|  | Form No.: 201.18-NM1 (LS1) | 1200 |
| LITERATURE SUPPLEMENT | File with: 201.18-NM1 (1298) | |
| Subject: Literature Error Regarding Priming Of YCAS Series F Compressors | | |

FIG. 1 - YCAS SERIES F COMPRESSOR

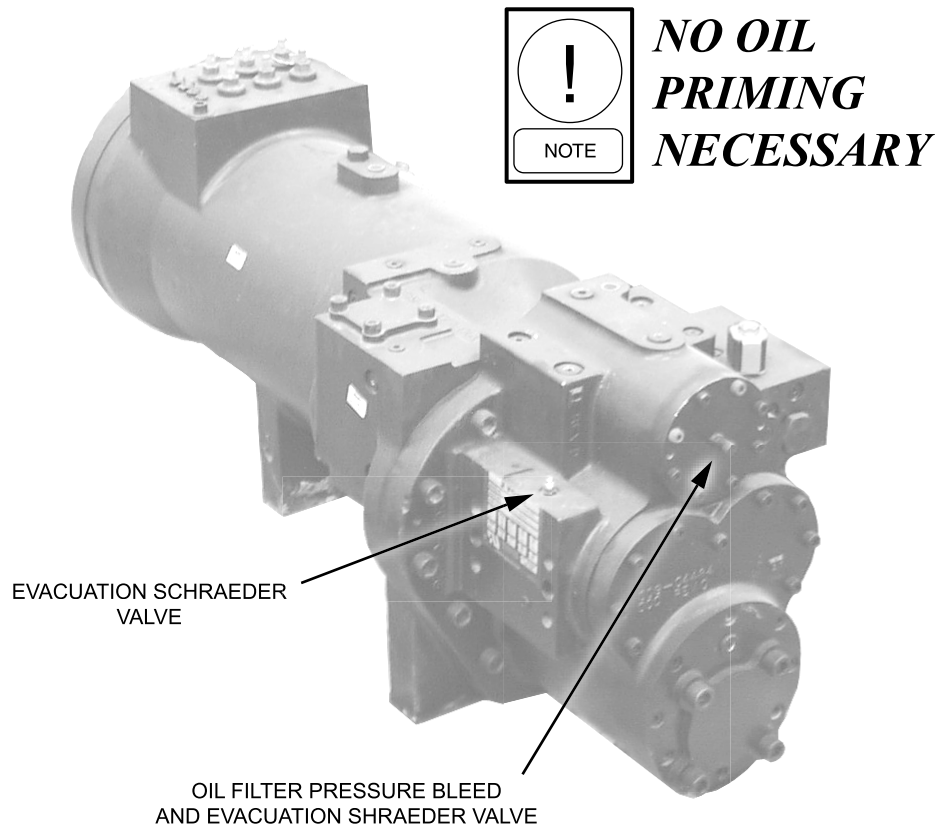
Page 35 of Form 201.18-NM1 (1298) incorrectly states that compressor lubrication systems must be primed before first time start-up. **The YCAS Series F compressor does not require priming**, has no oil sump, and no facilities for pumping oil into the compressor. Fittings on the compressor (see FIG. 1, below) should not be used for pumping oil into the system. If it is necessary to add oil, it should always be pumped into the oil separator.

When changing the oil filter cartridge, it is necessary to evacuate the compressor at both locations due to an internal check valve.
